THE CITY OF SAN DIEGO

REPORT TO THE PLANNING COMMISSION

DATE ISSUED: October 31, 2008 REPORT NO. PC-08-116

SUBJECT: DOTI POINT VIEWS - PROJECT NO. 1481. PROCESS 5

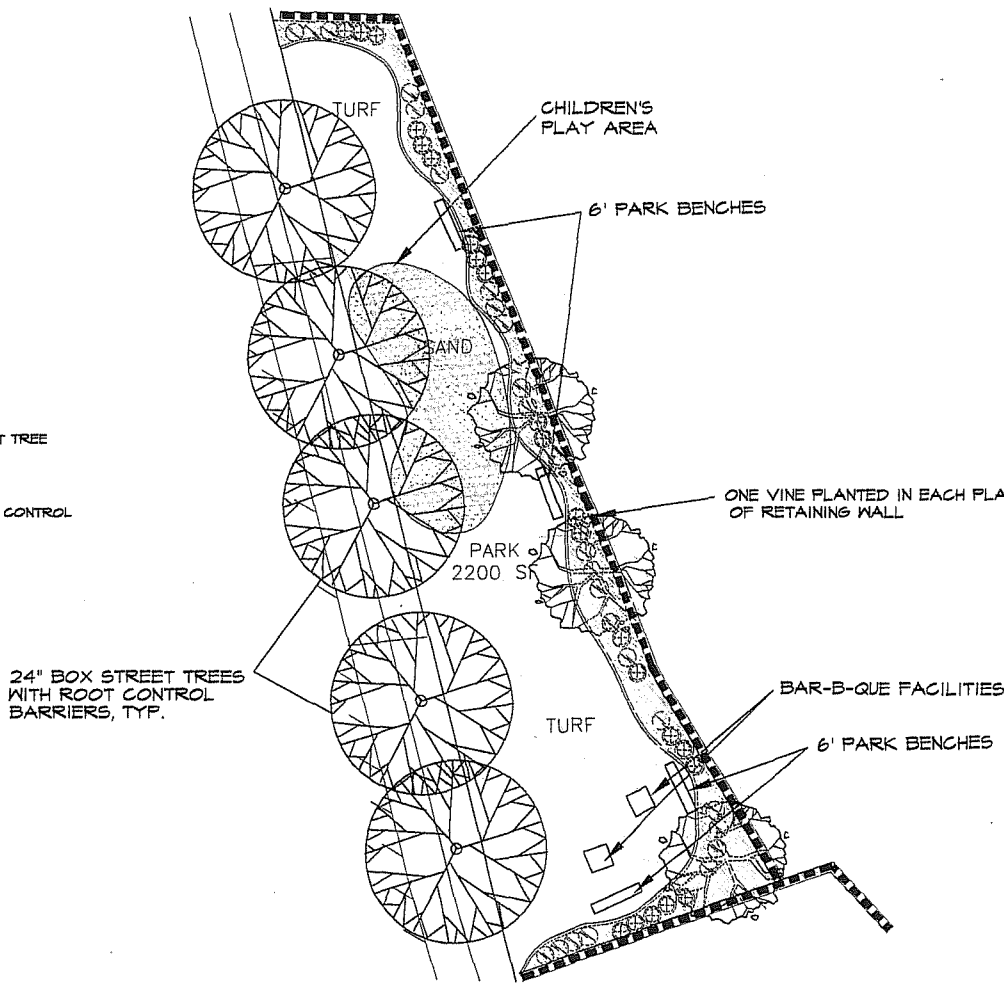
Staff Response: A typical wall section is provided on the Landscape Plan, Sheet 3 of 3.

Staff Response: A detail of the wall is indicated on the Landscape Plan. All walls have been reduced in height with the revised project. The northerly wall at the base of the embankment is no longer a structural part of the residences. Providing horizontal separations for this northerly wall would reduce rear yard areas.

SITE CROSS SECTION

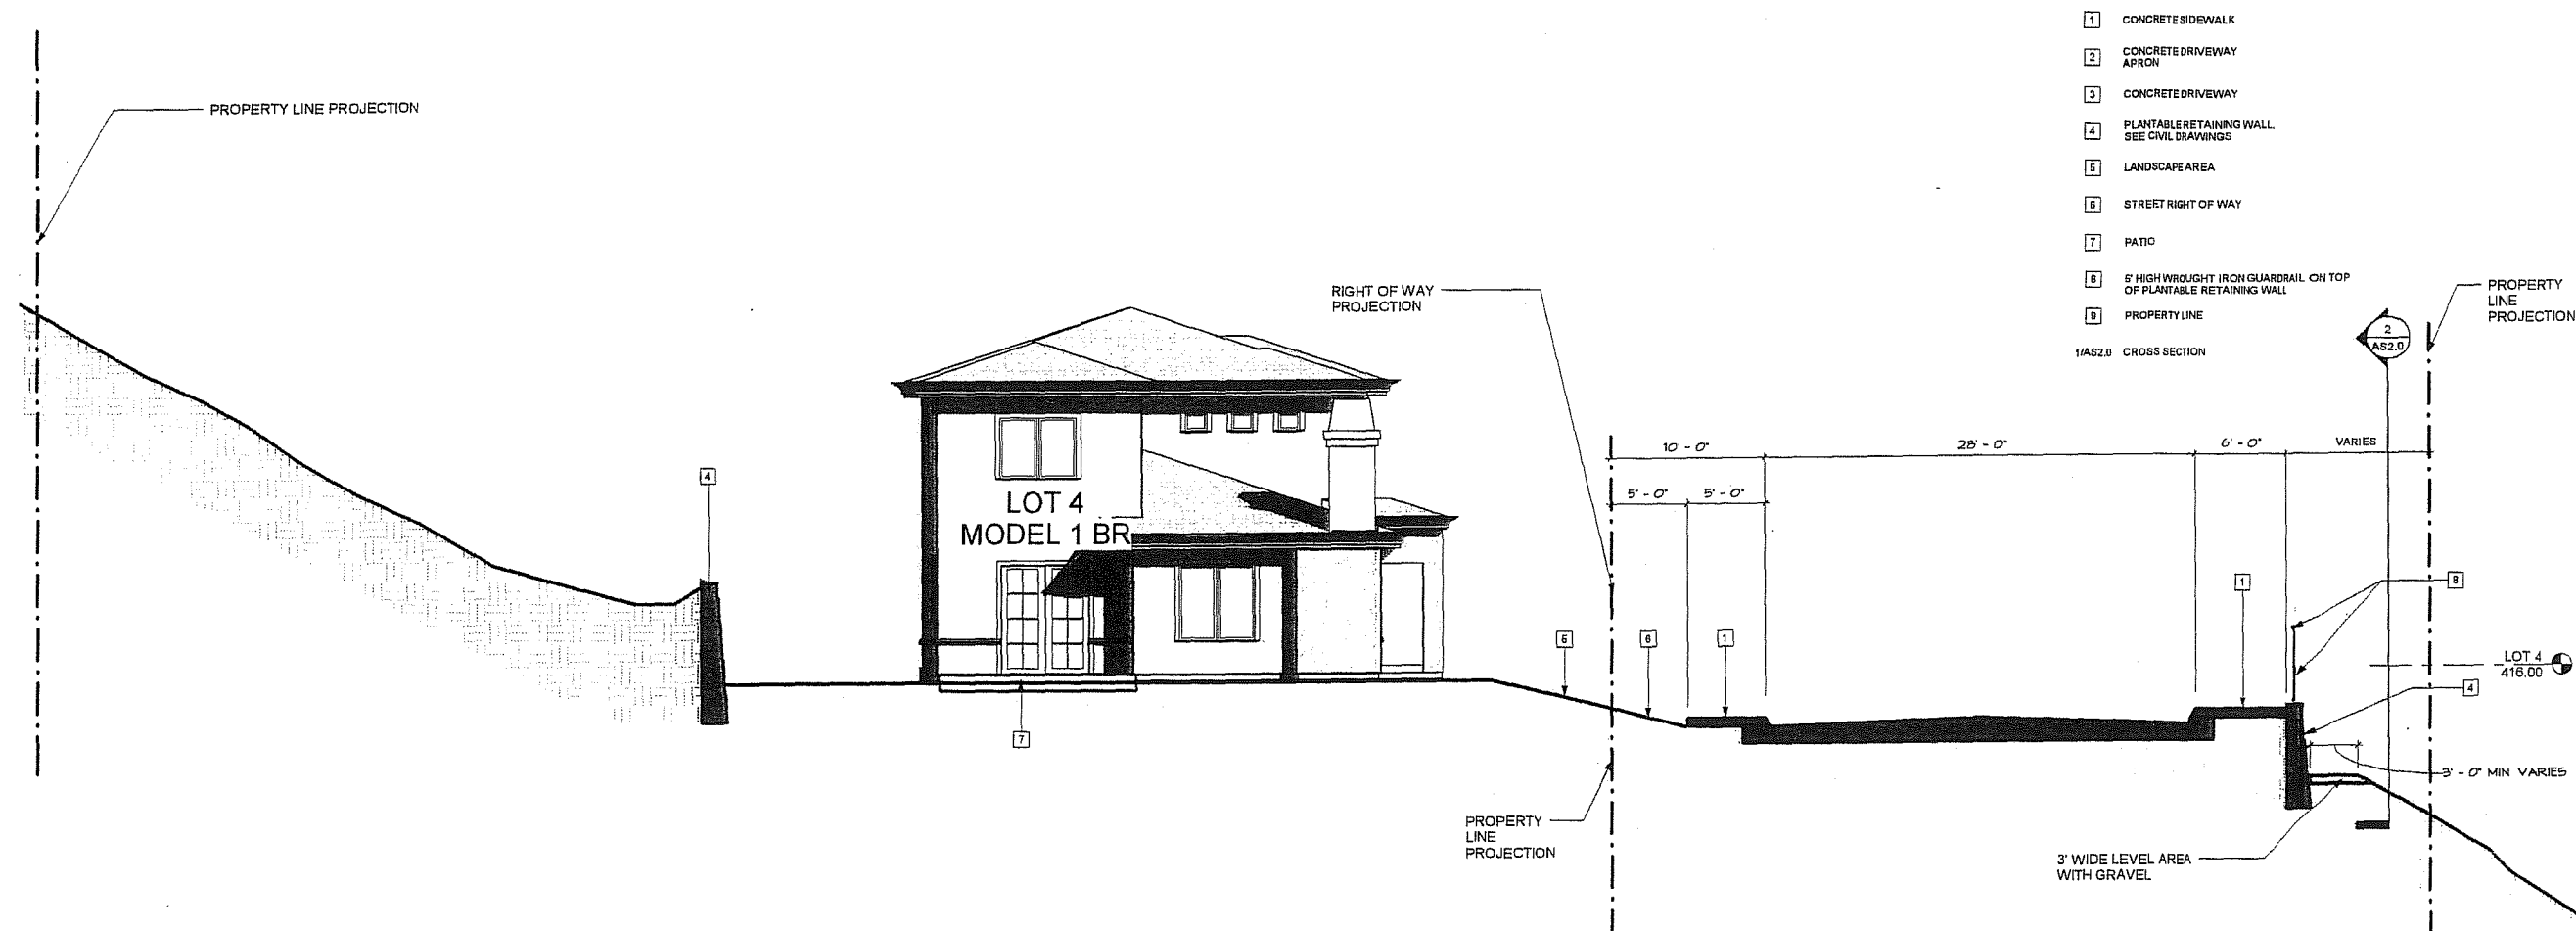
Staff Response: A 3-foot high wrought iron fence is proposed on top of the maximum 7-foot high plantable retaining wall on the south side of Wendy Way. Reference Attachment 10, sheet AS2.0 for detail.
